PUBLIC NOTICE
WOODLAND PARK PLANNING COMMISSION
Thursday, September 14, 2023, 6:30 P.M.
Council Chambers – 220 W. South Avenue

Planning Commission Staff Report Public Hearing September 14, 2023

Vacation: A request by applicant Derek Lutz (Farnsworth Group) and HSC Woodland Park, LLC (Property Owner) to consider a Conditional Use Permit and Site Plan Review, as well as a request to vacate the portion of Midland Avenue between Highway 67 and Burdette Street, for a proposed tire center store. The subject property is located at the NW corner of Midland Avenue and Highway 67 with a legal description of Lot 2, L. Clifford Filing No. 2, Woodland Park, Colorado and is zoned Service Commercial (SC). (QJ)

I:\mormon\1_0230112\0230112.00 - L300 - Woodland Park_Civil_Drawings\DWG-D-100 HISTORIC DRAINAGE PLAN.dwg | 6/30/2023 8:36 AM |

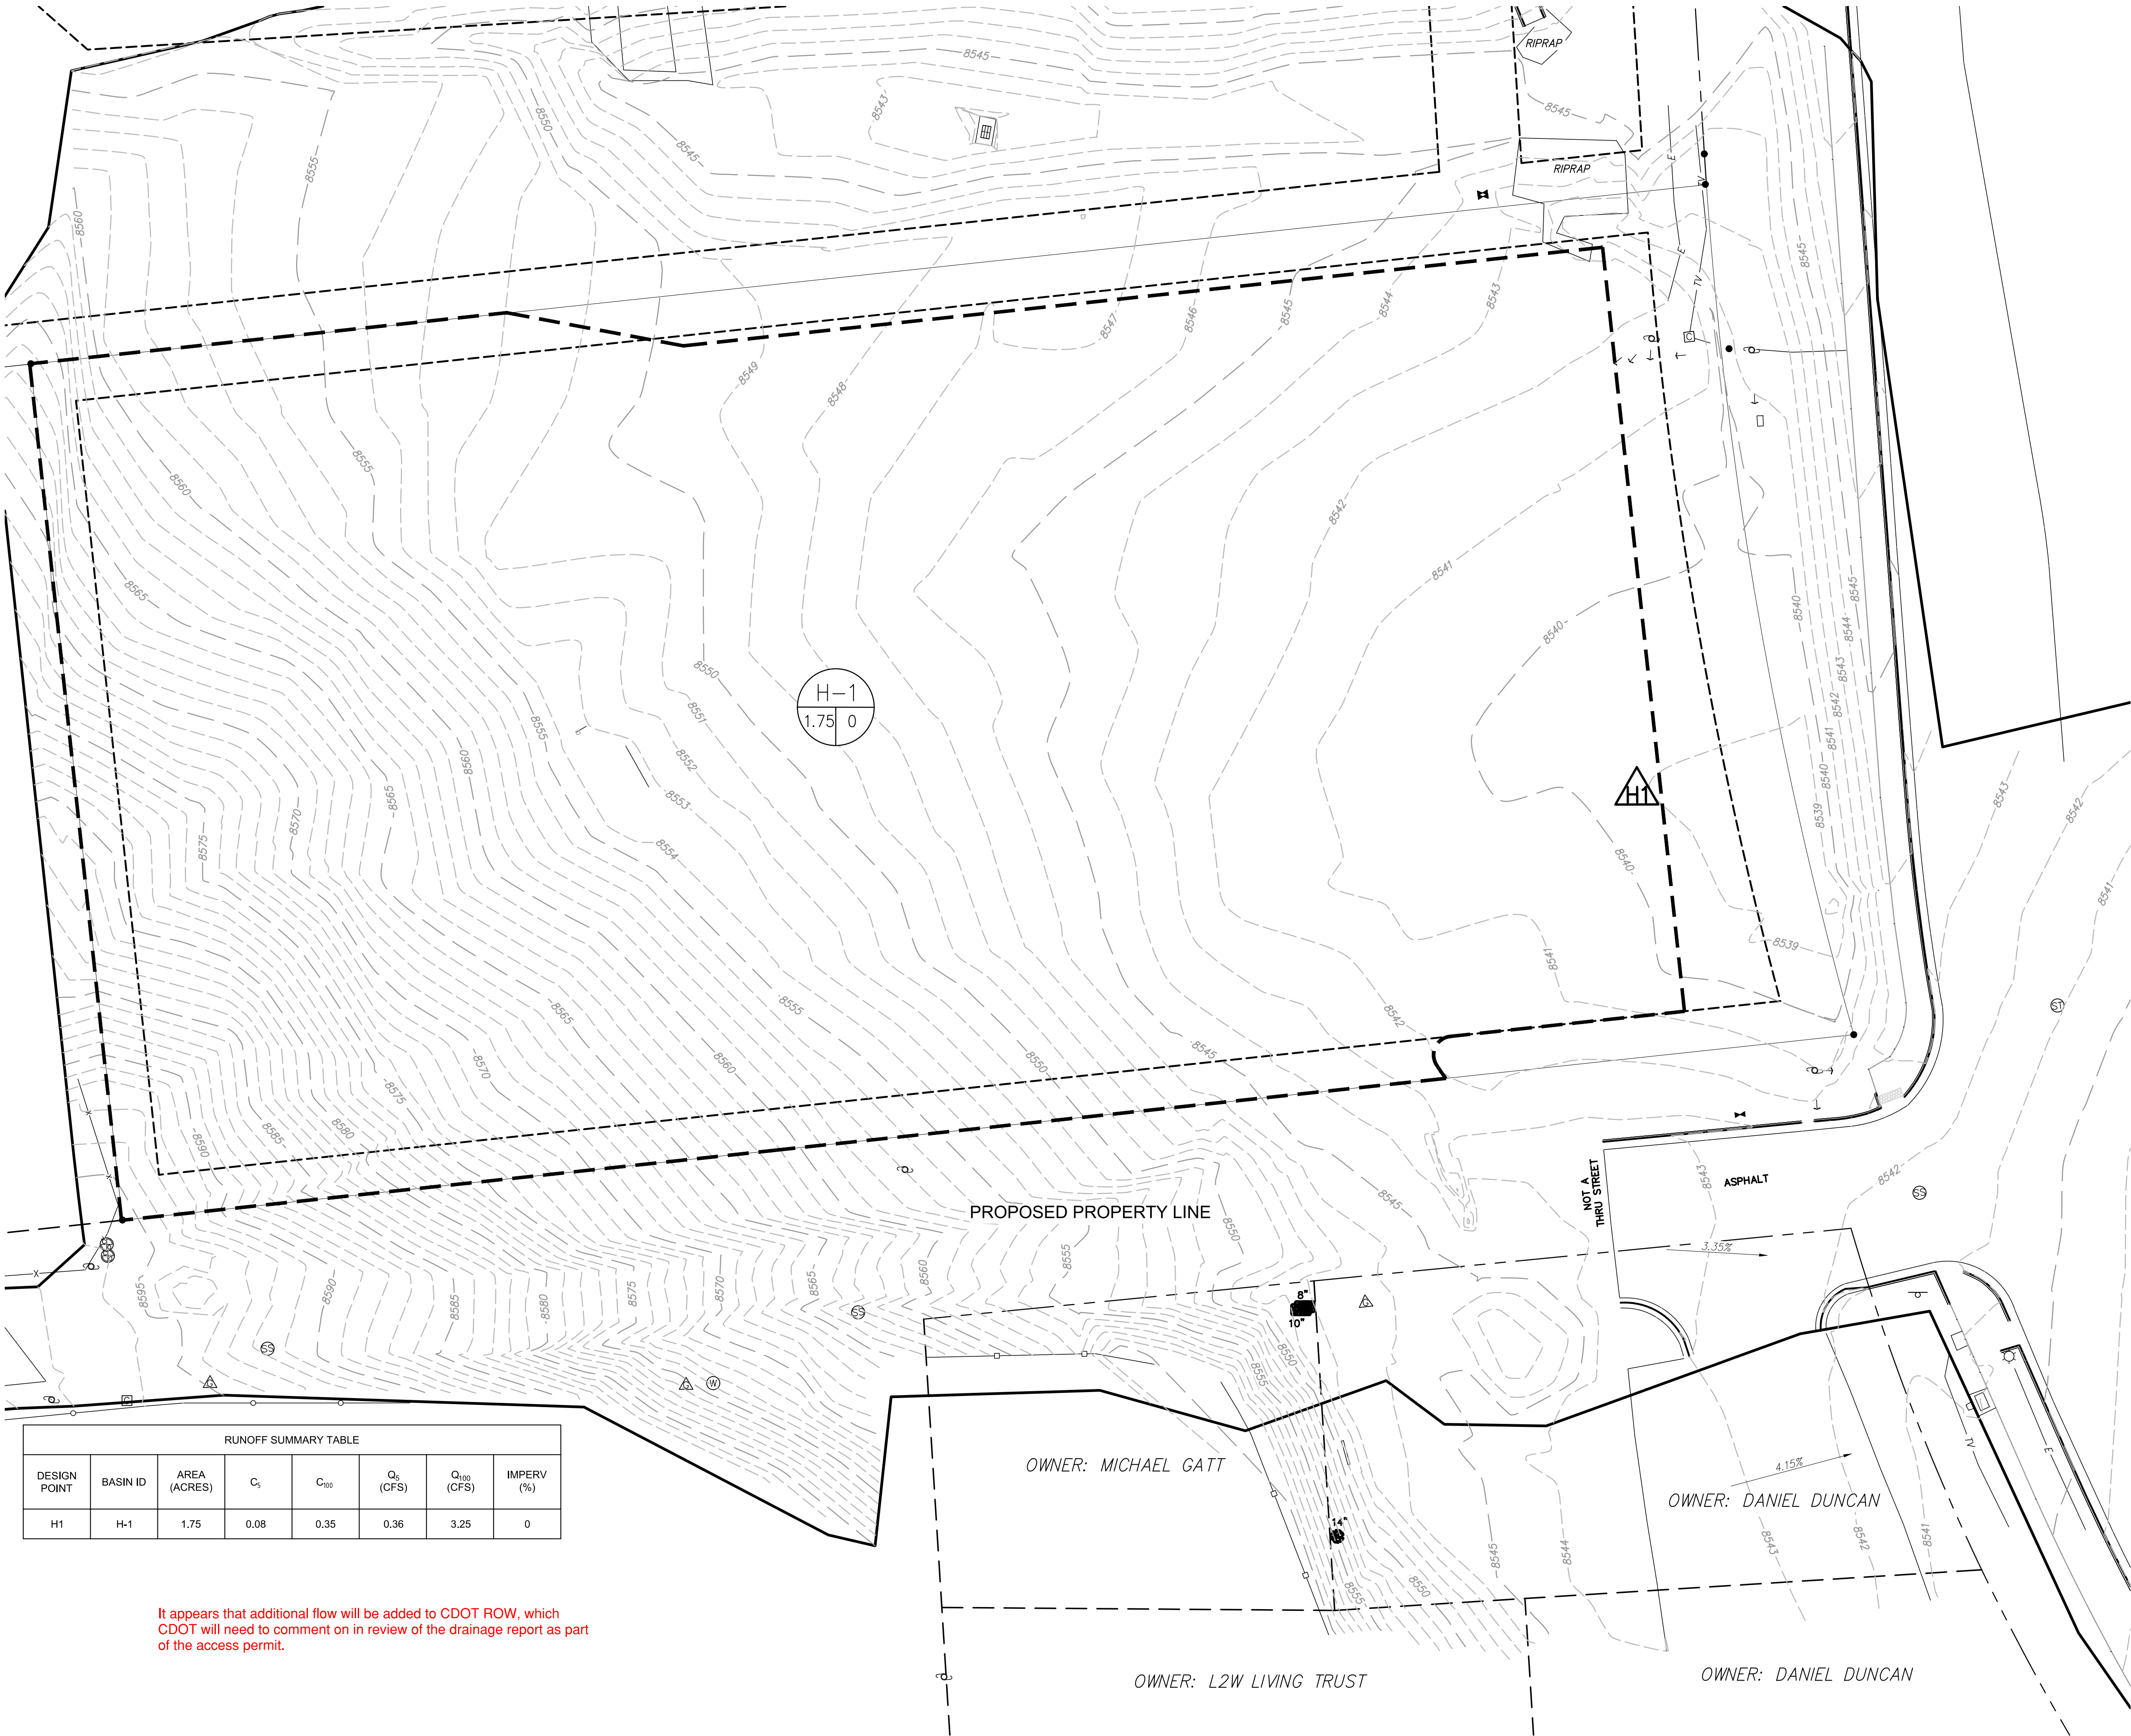
It appears that additional flow will be added to CDOT ROW, which CDOT will need to comment on in review of the drainage report as part of the access permit.

SITE PHOTOMETRIC
PLAN

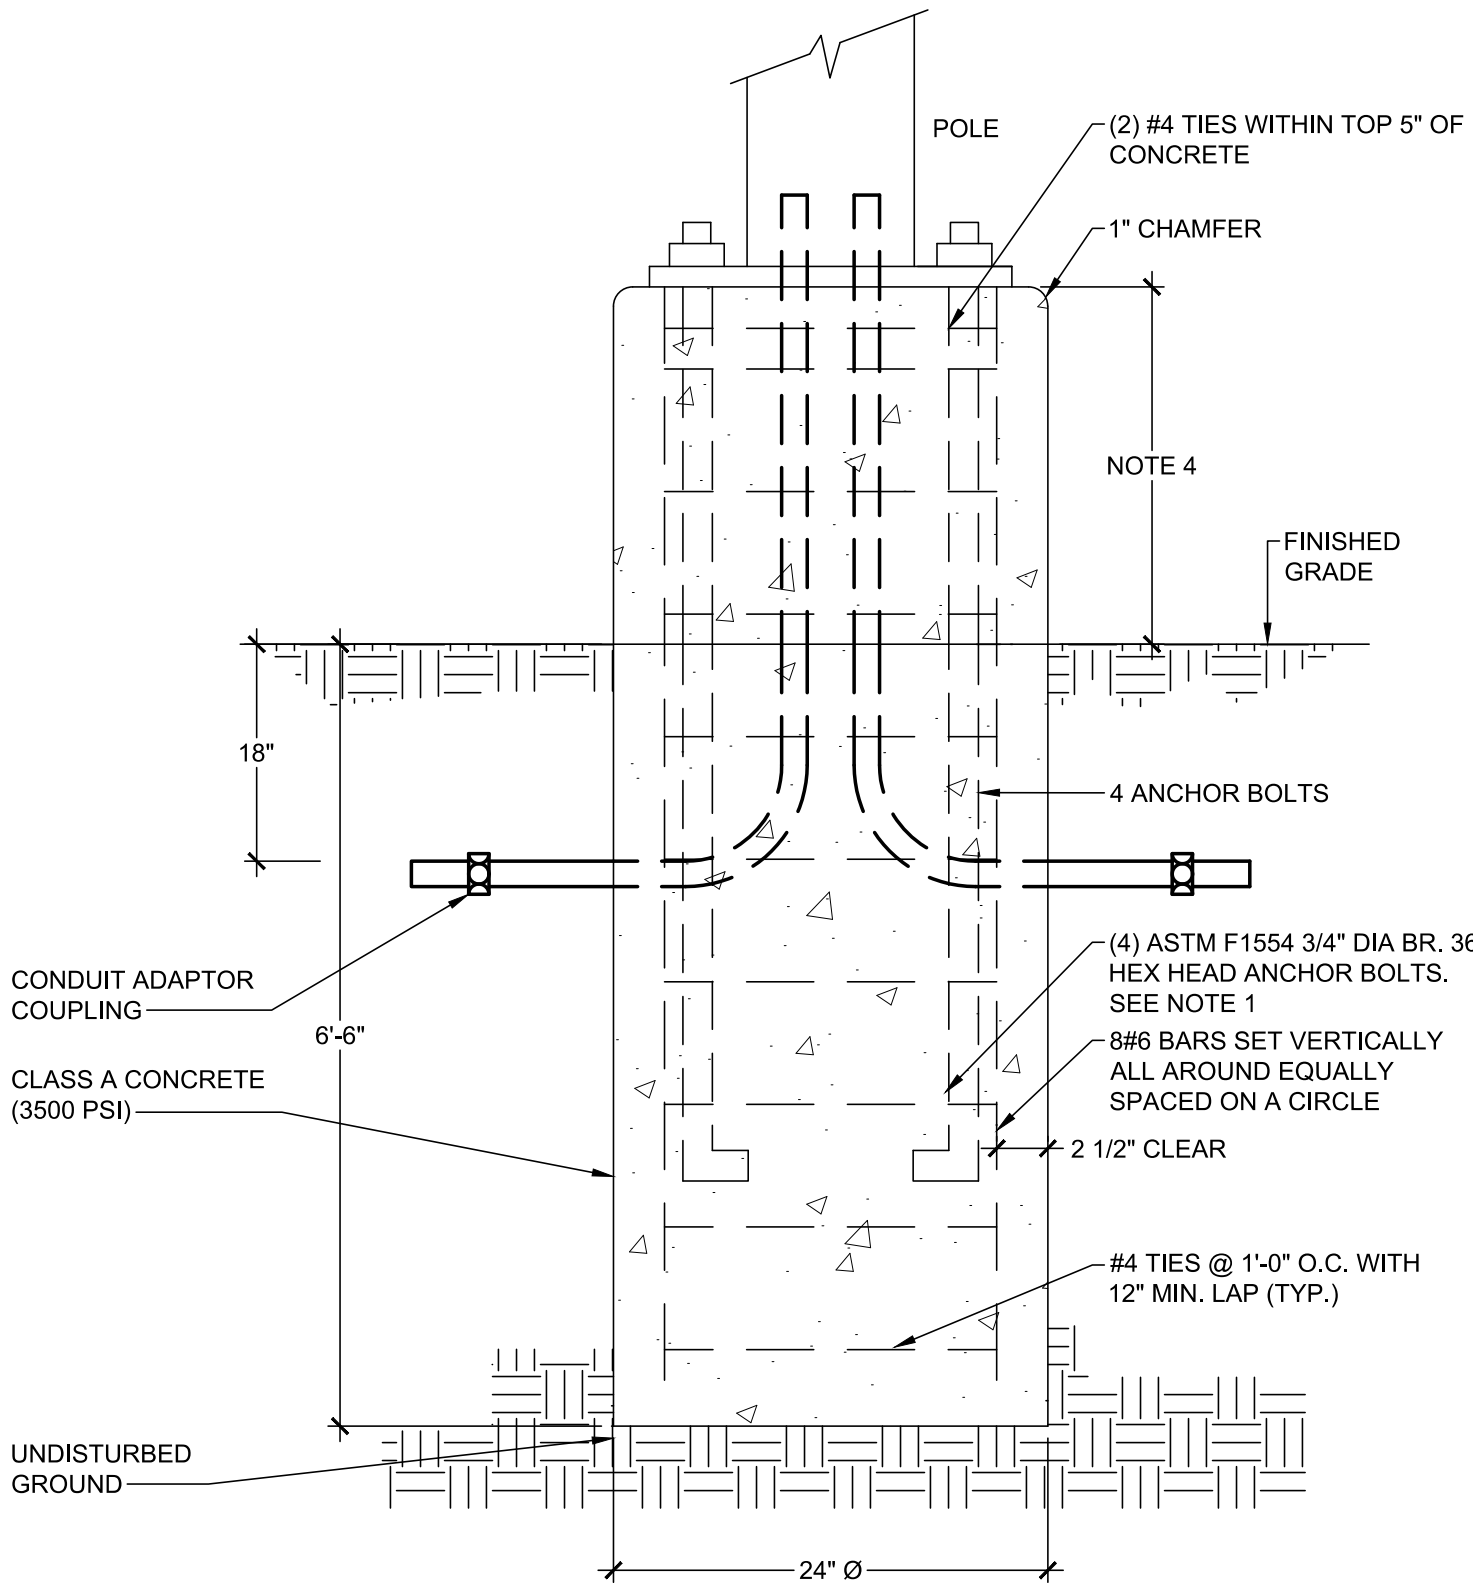
Is this the total height
of the mounted
lighting?

1 UTILITY PLAN
SCALE: 1"=20'

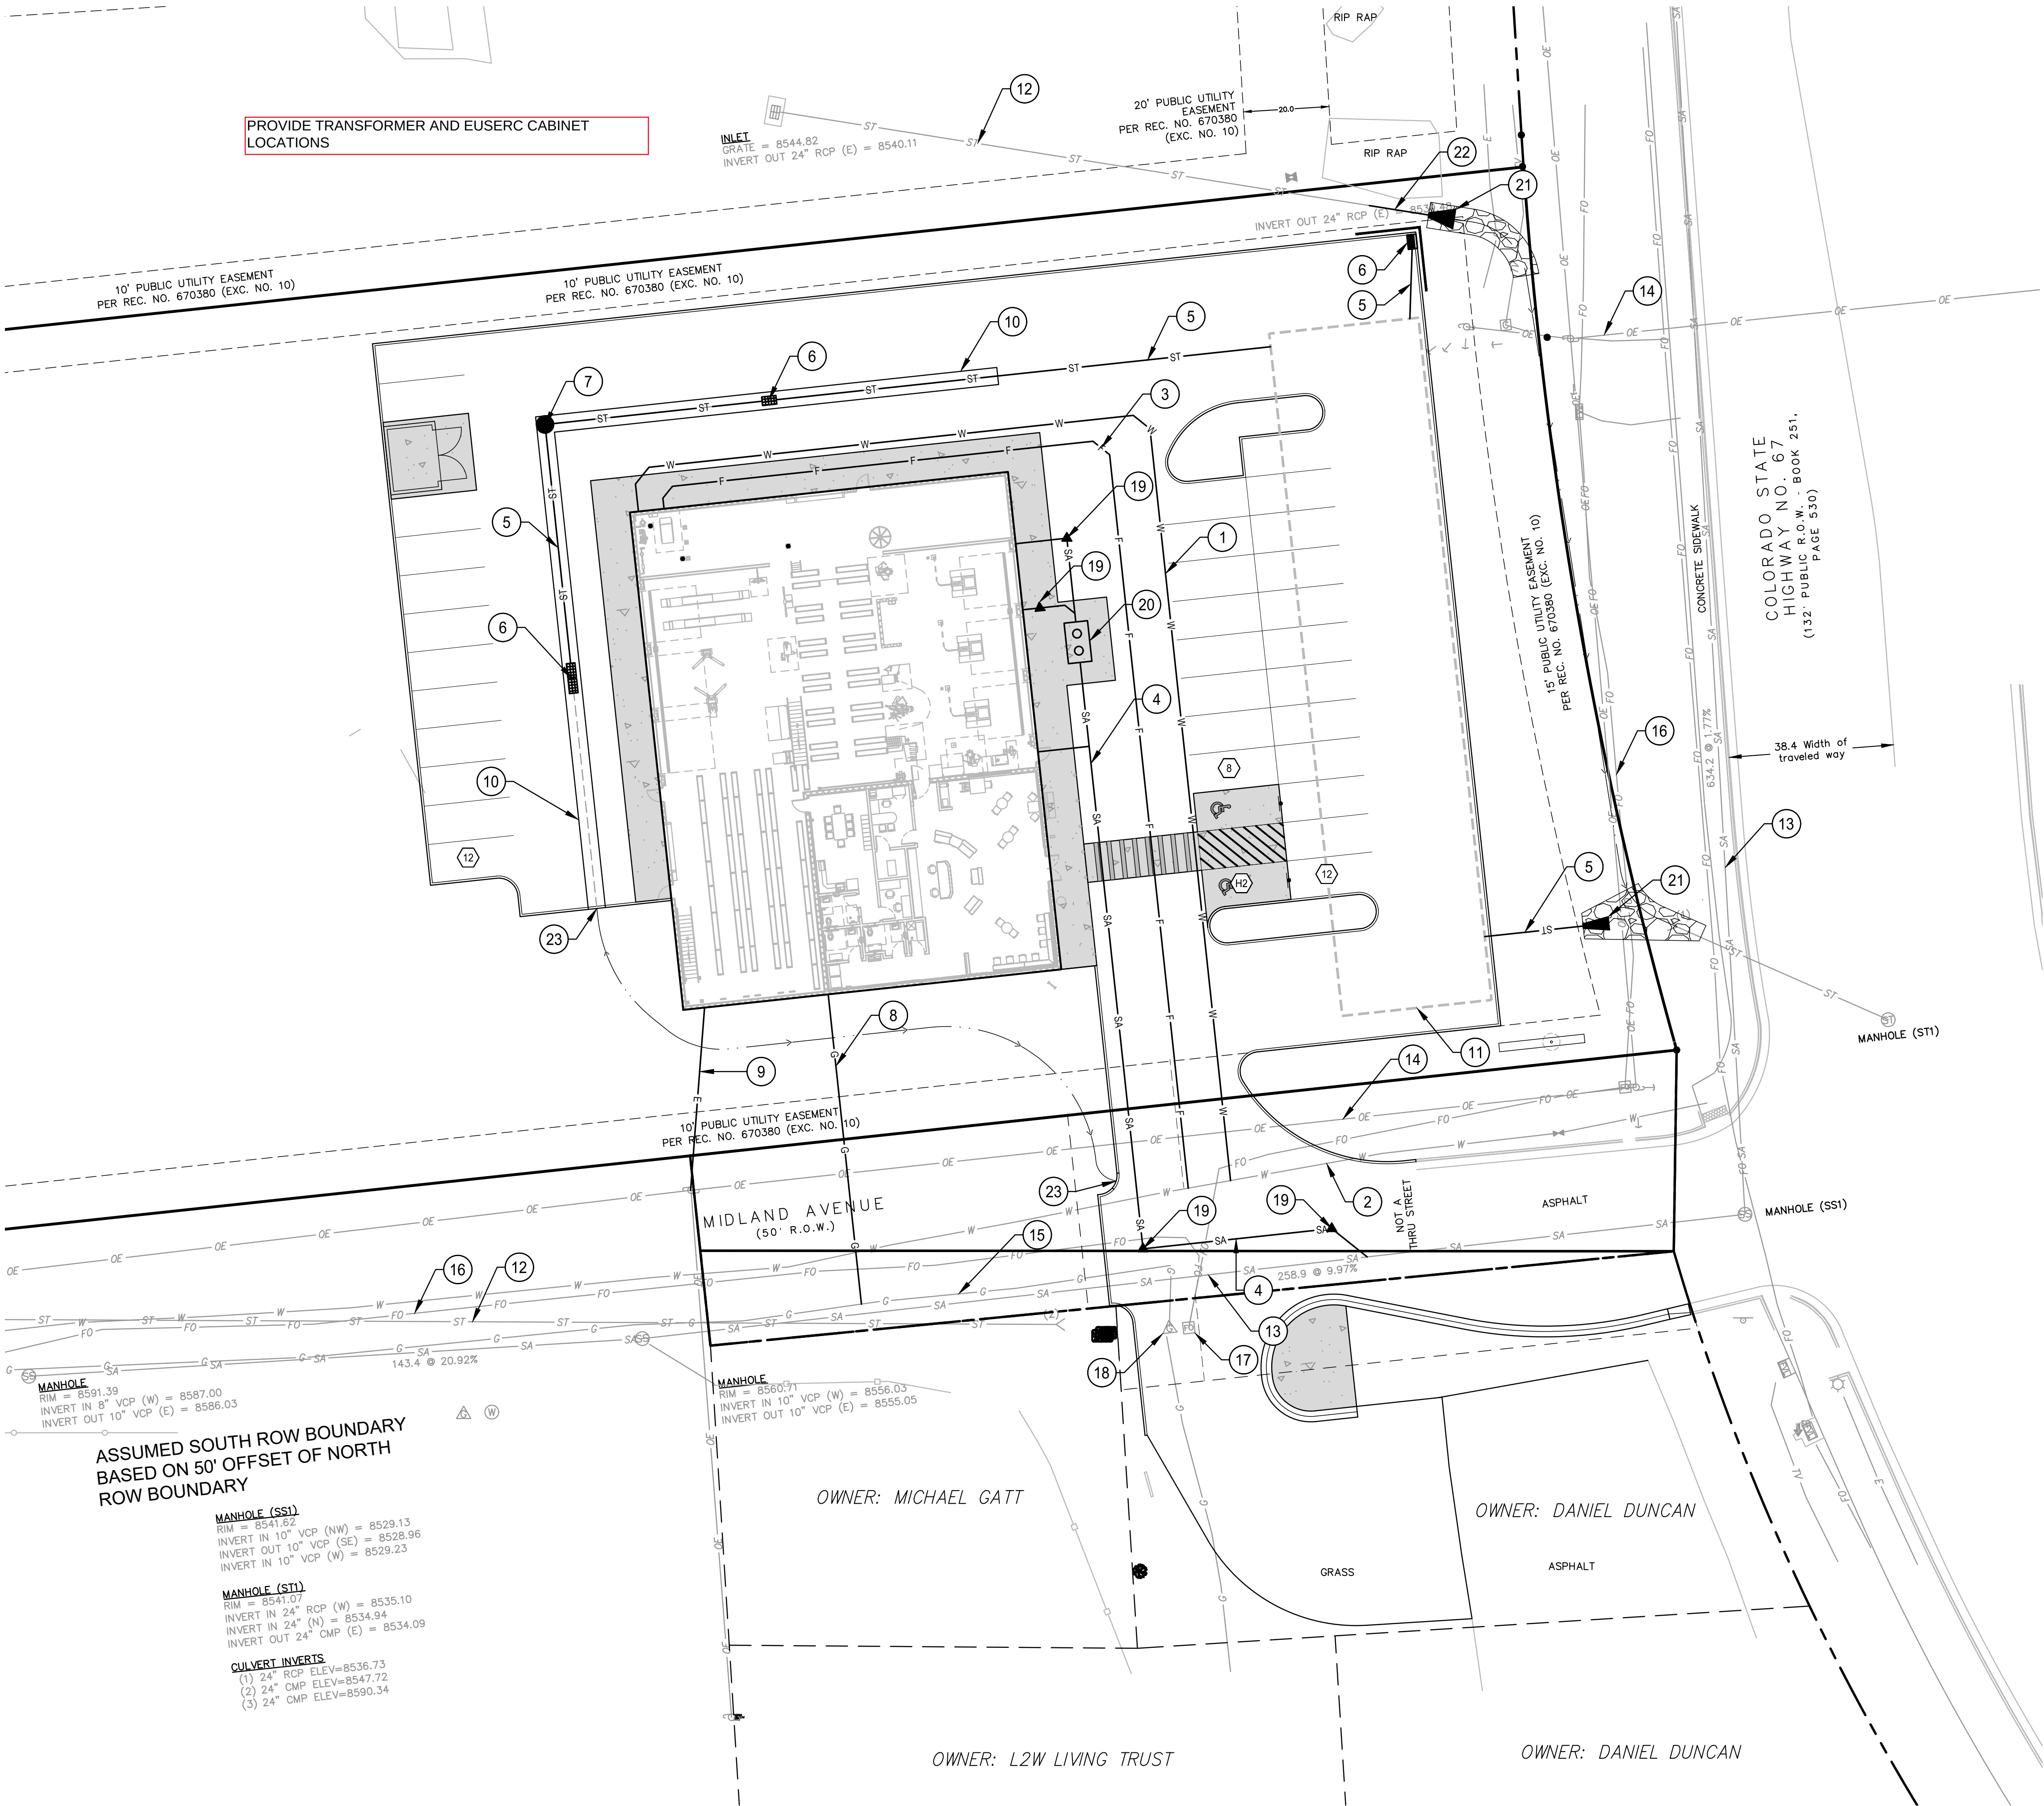
PROVIDE TRANSFORMER AND EUSERC CABINET LOCATIONS
